JAMES A. FITZPATRICK NUCLEAR POWER PLANT
POWER AUTHORITY OF THE STATE OF NEW YORK
P.O. No. 514-1A
REACTOR WELL SEAL
GE
P.O. No.
WRITER FEB 02 1970 W.J.M.
WRITER FEB 26 1970 L.B.M.
WRITER MAR 4 - 1970
WRITER MAR 5 - 1970
WRITER MAR 7 - 1970
STATUS
APPROVED AS REVISED
APPROVED
Date 4/13/70 BY GE
(HMZ)

TITLE ARRANGEMENT — REACTOR WELL SEAL
FIRST MADE FOR GENERAL LAYOUT DRAWINGS

FITZPATRICK NUCLEAR PLANT
MPL 1-8
PO 205-

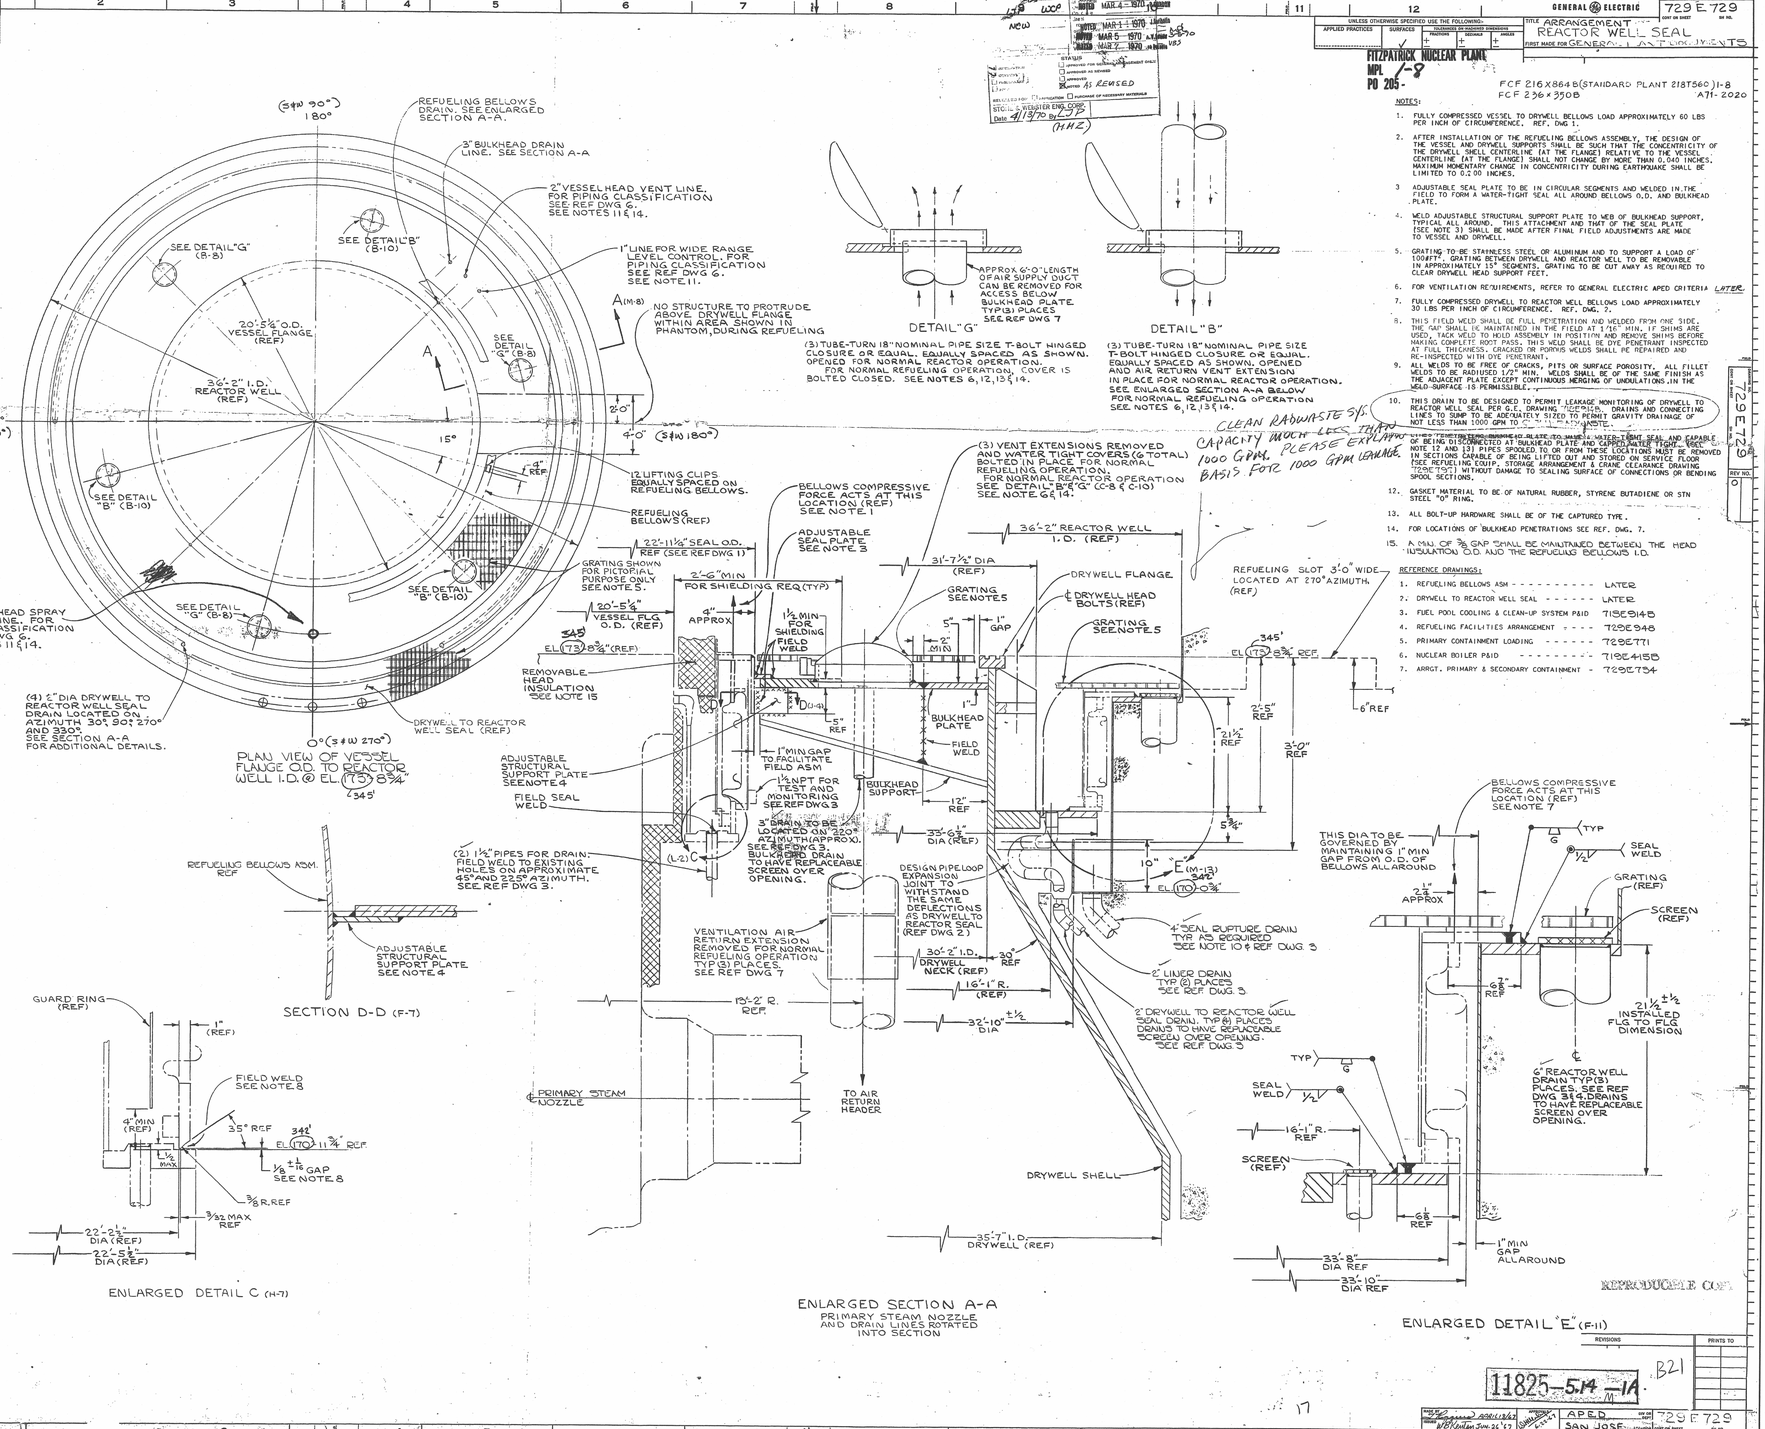
CLEAN RADWASTE S/S CAPACITY MUCH LESS THAN 1000 GPM. PLEASE EXPLAIN BASIS FOR 1000 GPM LEAKAGE.
